Docket Number:	79-AFC-04C
Project Title:	Compliance - Application for Certification of DWR Bottlerock Geothermal Project
TN #:	268604
Document Title:	BOTTLEROCK CEC DATA REQUESTS RESPONSE 2-3-2026
Description:	BOTTLEROCK CEC DATA REQUESTS RESPONSE 2-3-2026
Filer:	John C Casteel
Organization:	Mayacma Geothermal LLC
Submitter Role:	Applicant
Submission Date:	2/12/2026 3:47:33 PM
Docketed Date:	2/12/2026

DATA REQUESTS – SET NO. 6 – TRANSMISSION SYSTEM ENGINEERING BOTTLE ROCK
GEOTHERMAL POWER PLANT (79-AFC-04C)

Figure 1: Interconnection Overview

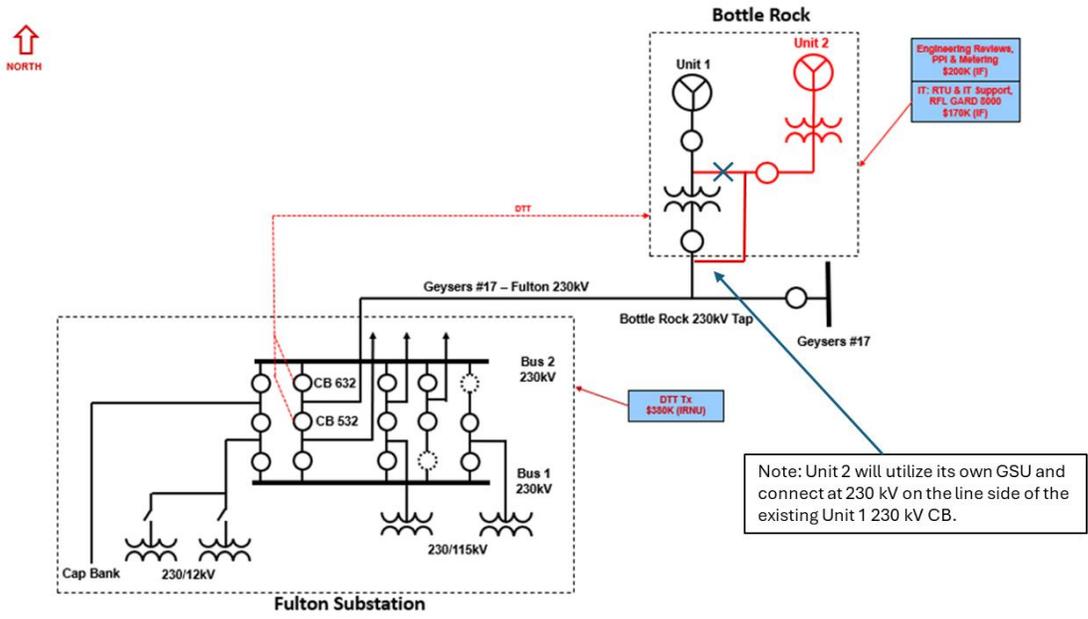
1. Please discuss the route of the proposed generator tie line to the new generators in more detail and provide the following information:

- **The tie line conductor type, size and ampacity.**
- **One-line diagram of the proposed generator tie line indicating the transformer and breakers ratings.**

The repowered geothermal facility will utilize two 5.5 MW ORC units and will be connected to a standalone 13.8 kV MV switchgear lineup with dedicated breakers and protection. From the 13.8 kV bus, output will be stepped up through a new 13.8/230 kV GSU transformer, segregated from the existing transformer. The new 230 kV gen-tie will route from the GSU high-side to the existing Bottle Rock 230 kV Tap, which ties into the Geysers #17 - Fulton 230 kV transmission line at the POI.
